Design Review Board

Proposed Site Addition - Public Storage

700 Fairview Avenue N

September 2012

POTENTIAL FUTURE USE - RESIDENTIAL PARKING PLAN (1ST FLOOR)

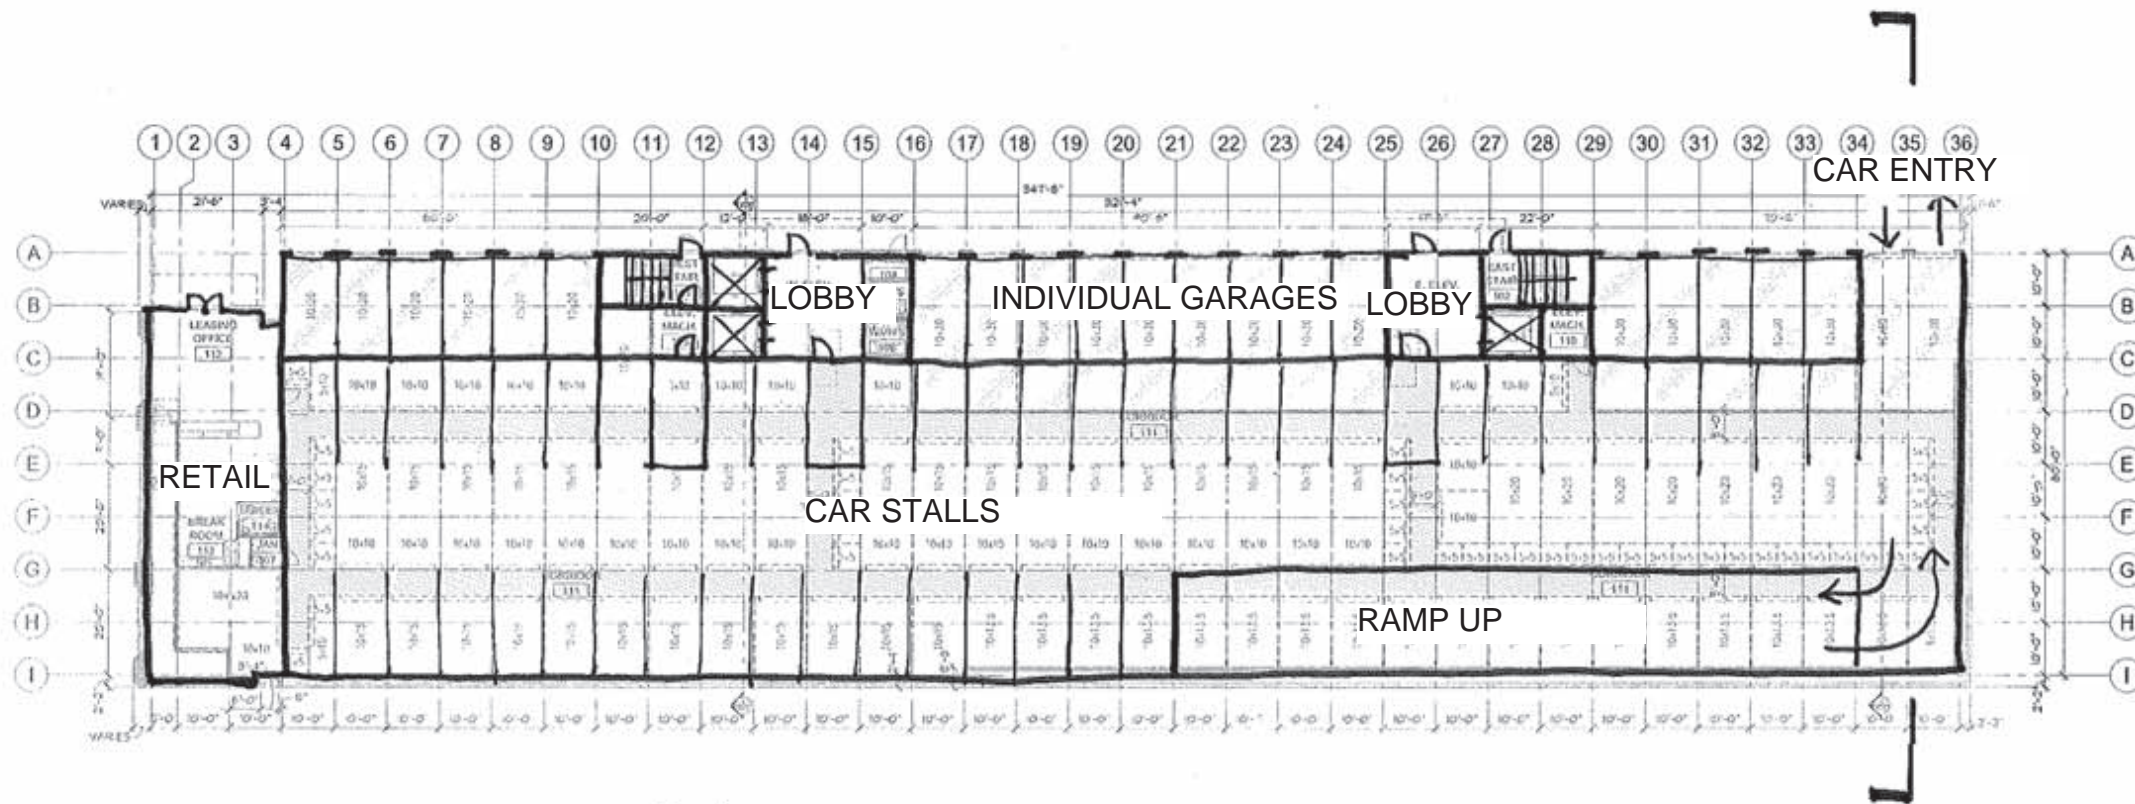
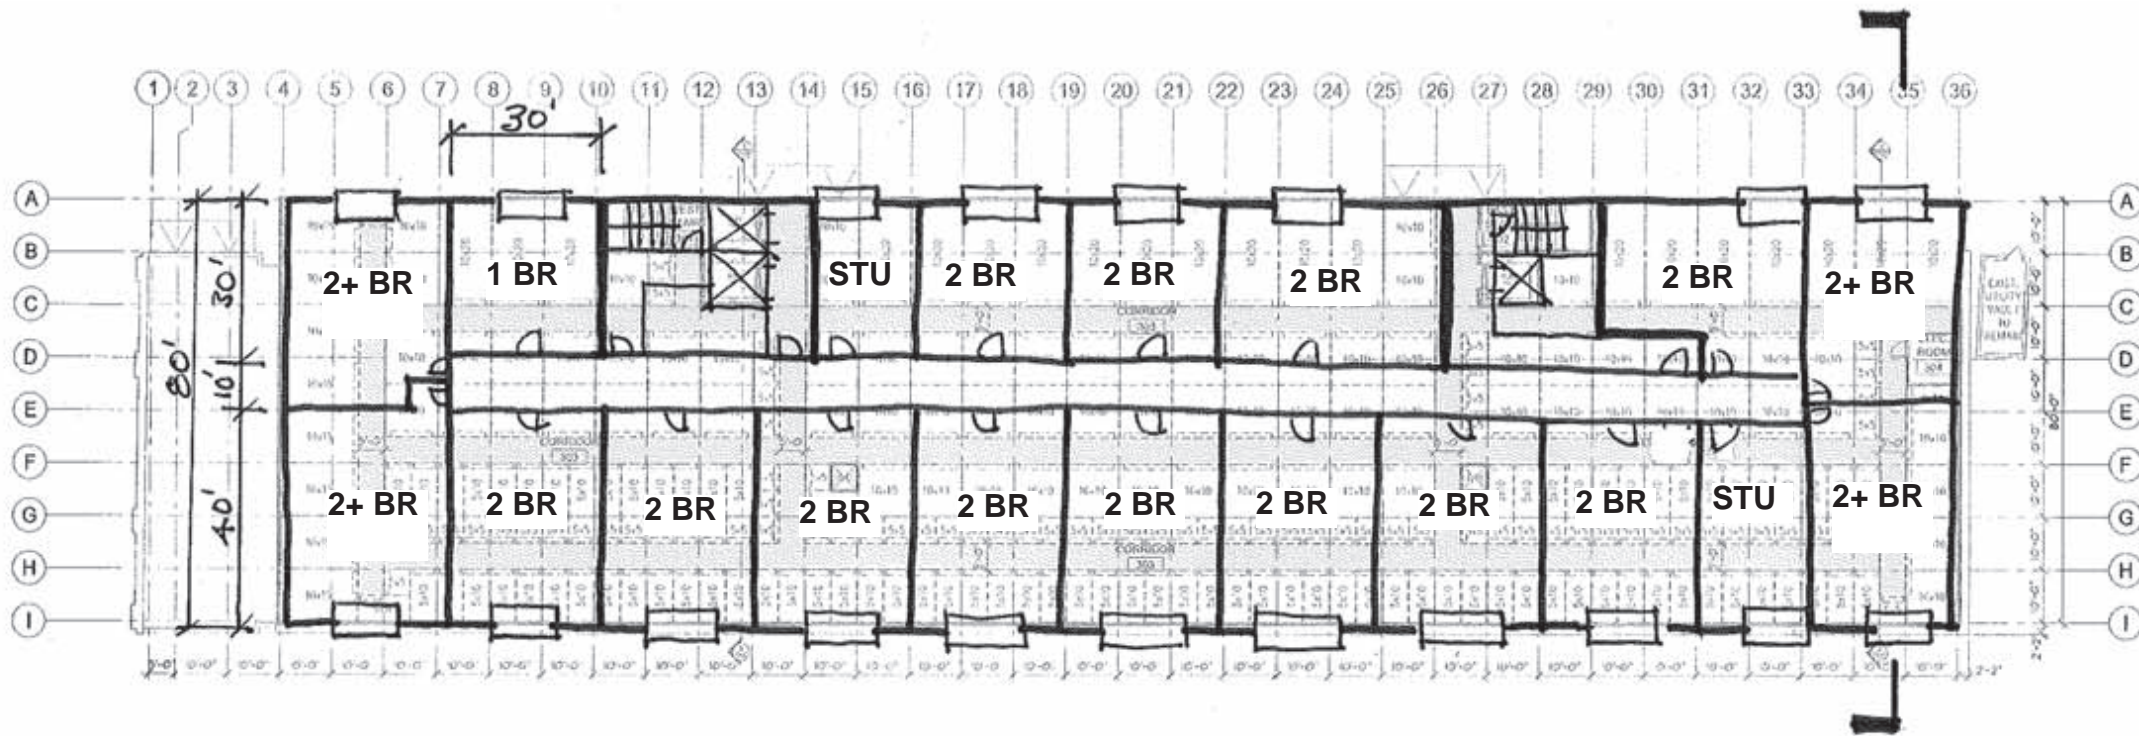
The Board would like to see a detailed design of the floor plan and building section detail to better understand adaptability of future uses.

Response: These will be included in the Design Review Board packet.
